Addendum # 5

Bid Opportunity: 25-7748-RFT - St. Andrew's Public School 3rd Floor Classroom Refinishing Closing Date: Wednesday, May 21, 2025 2:00 PM

Addendum #4

Addendum #:	E-1
--------------------	-----

3. Drawing E-203 – Second Floor Demolition & New Work Plans – Power & Systems (Issued herewith):

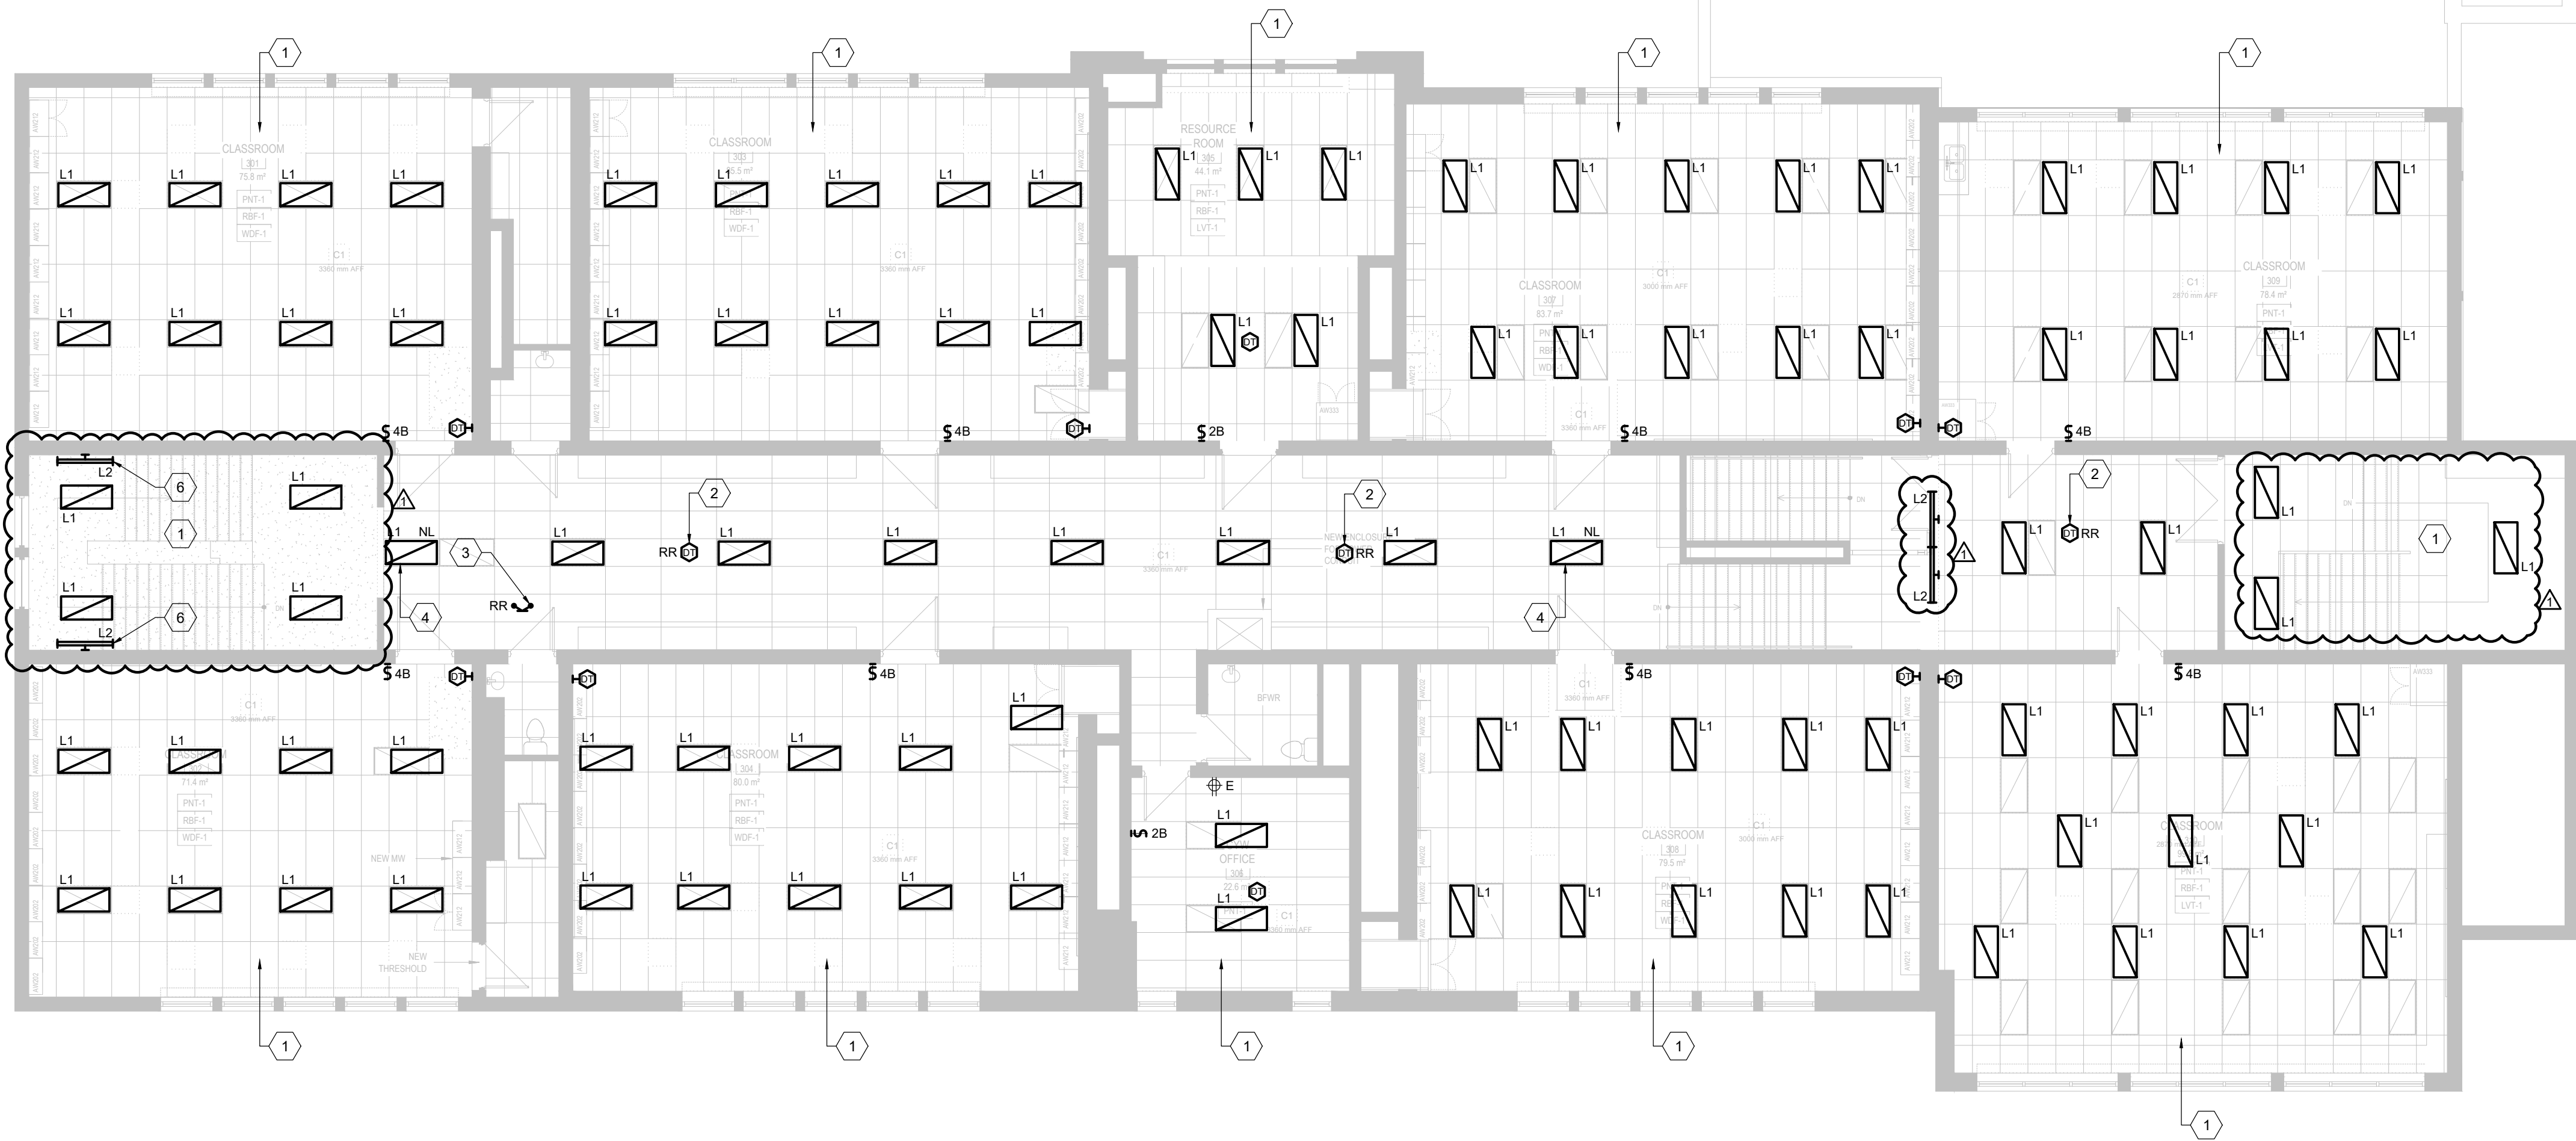
- a. Refer to attached, revised drawing #E-203 and provide all changes indicated. Modifications include, but are not limited to the following:
 1. Added Demolition Key Notes.
 2. Revised New Work Key Notes #3, #4, #5 and #6.
 3. Demolition Plan: added key note references for PA, fire alarm, WAP devices, etc.
 4. Demolition Plan: added additional removal and reinstallation of fire alarm detectors at stairwells.
 5. Demolition Plan: added existing to remain devices and existing devices to be removed to accommodate new millwork installation.
 6. New Work Plan: added existing to remain devices.
 7. New Work Plan: added reinstallation of PA, fire alarm, WAP devices, etc. for devices noted on demolition drawings.
 8. New Work Plan: added additional new receptacle devices – connect to branch circuits indicated.

E-101

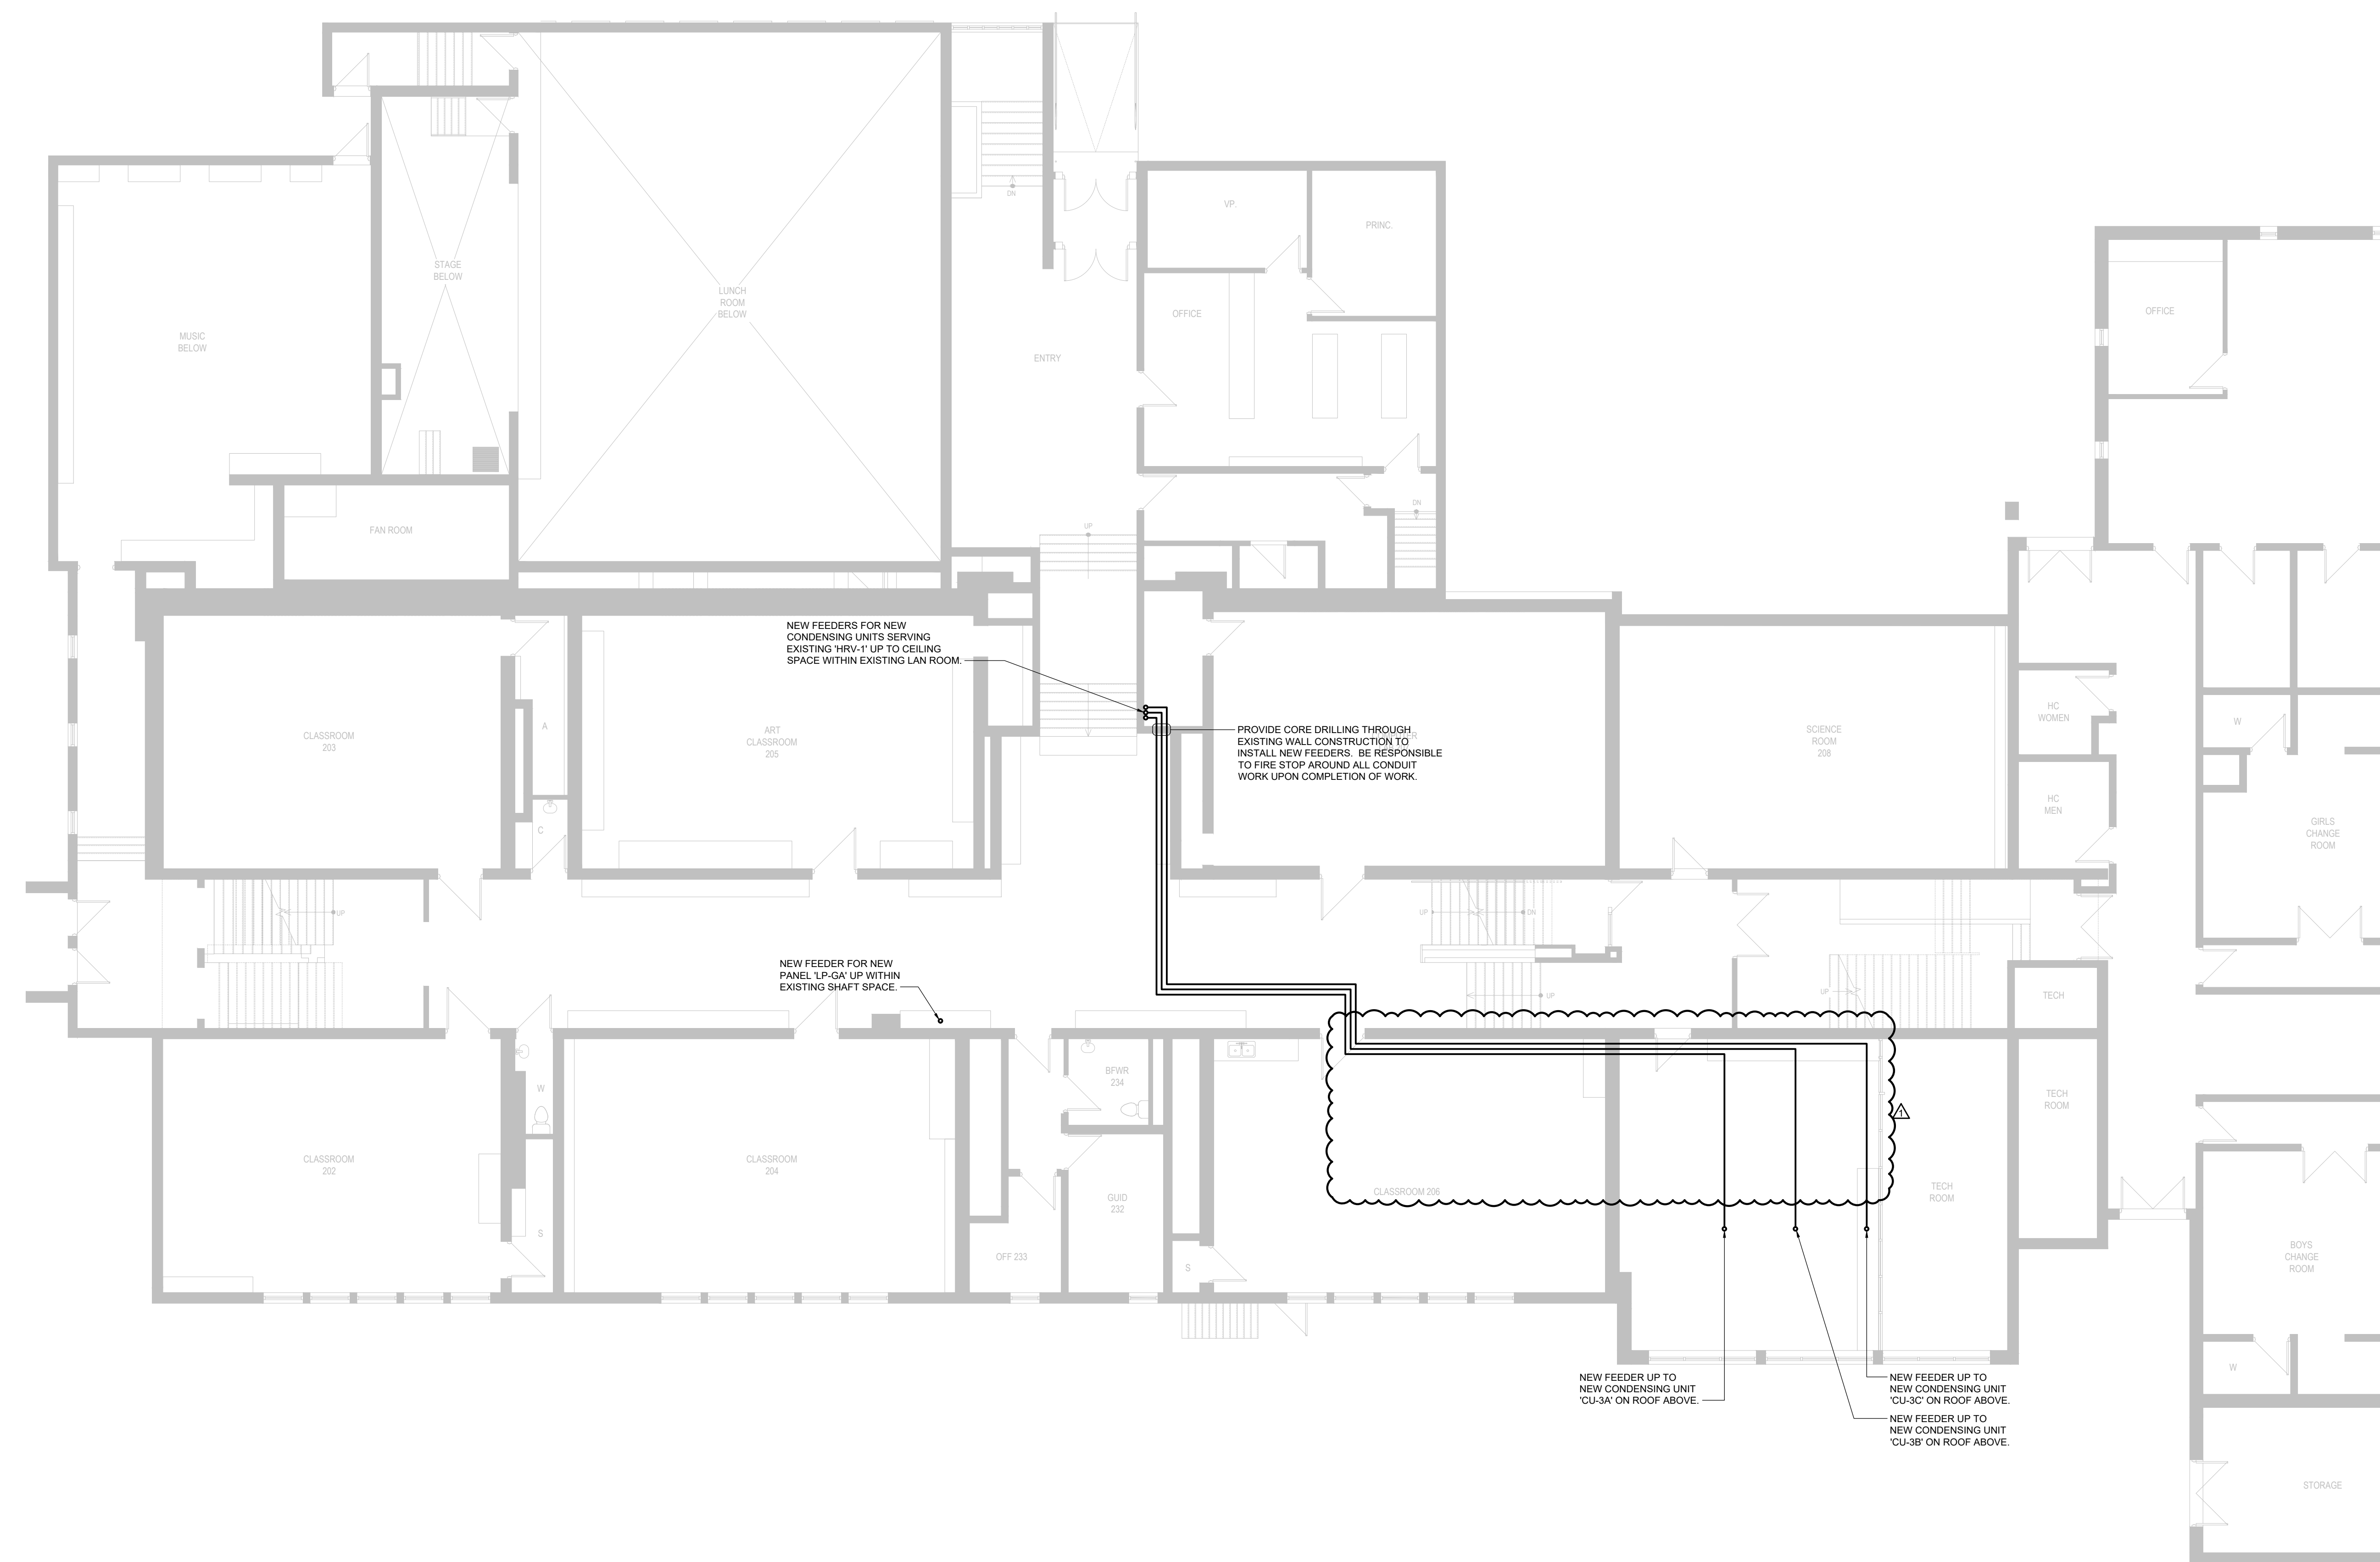
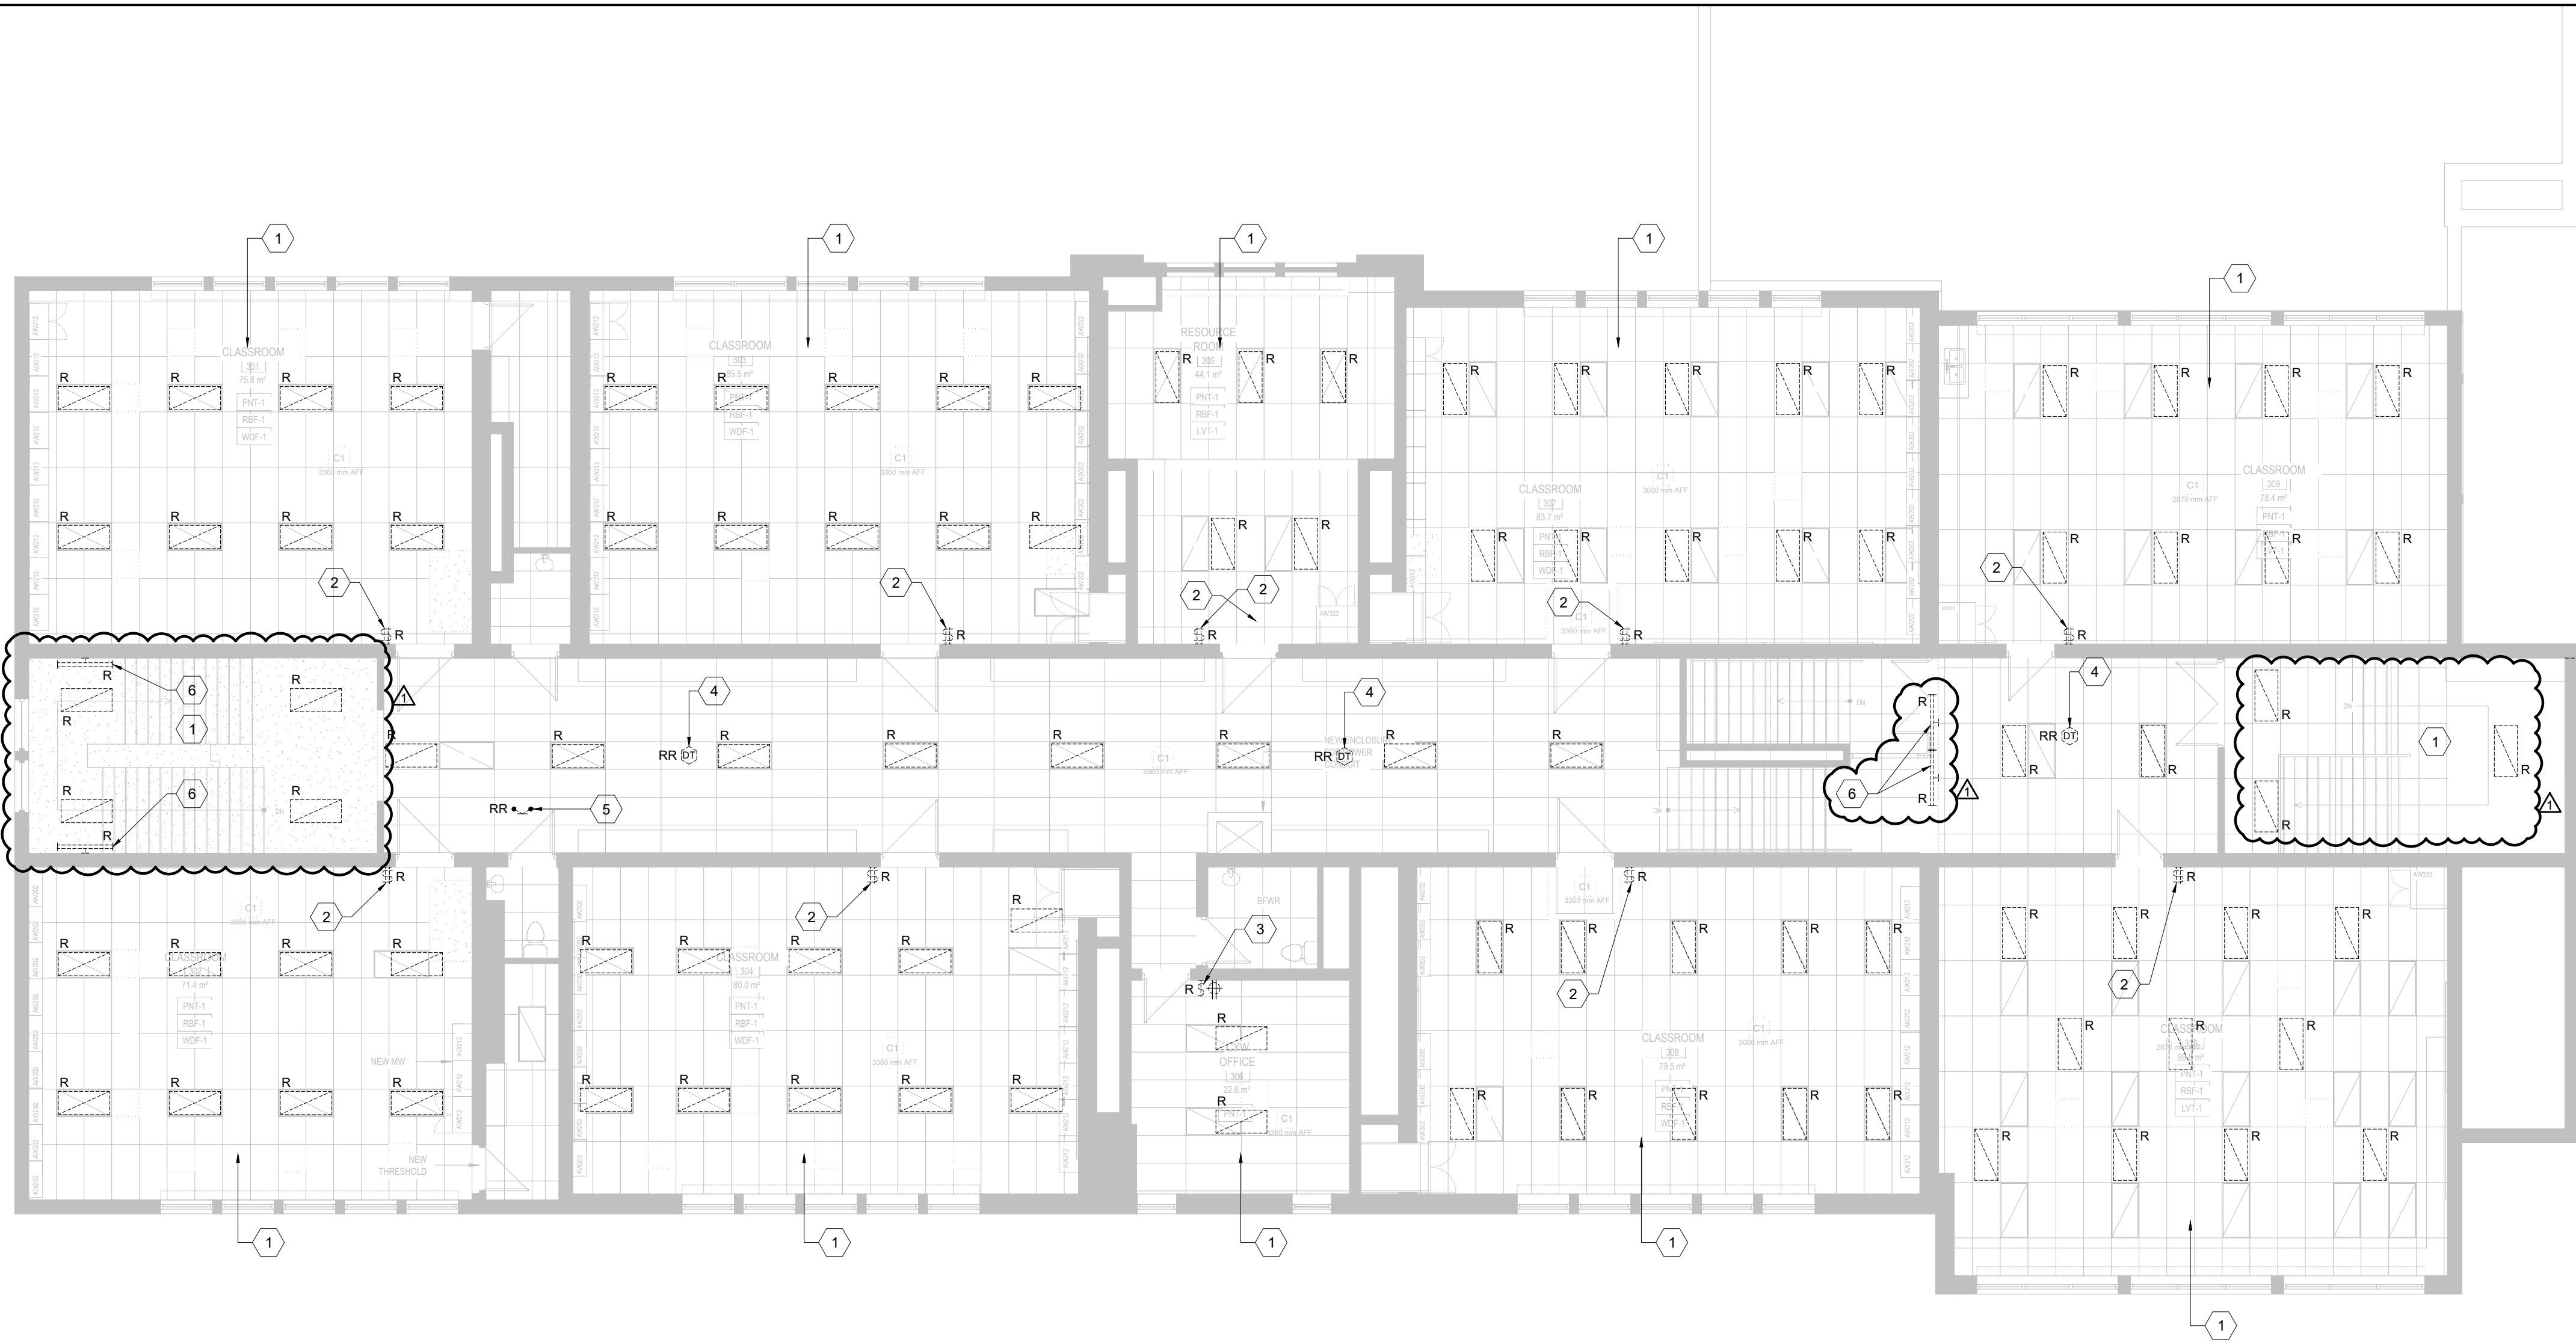
Changes to Drawings
1. Drawing E-101 – Second Floor Demolition & New Work Plans – Lighting (Issued herewith):

- a. Refer to attached, revised drawing #E-101 and provide all changes indicated. Modifications include, but are not limited to the following:
 1. Added note #6 to demolition key notes.
 2. Demolition Plan: removal of existing luminaires in existing stairs.
 3. Demolition Plan: removal of two wall mounted lights within corridor.
 4. New Work Plan: provision of new lighting within existing stairs and reconnection to existing circuits.
 5. New Work Plan: provision of new wall mounted lighting within corridor and reconnection to existing circuits.
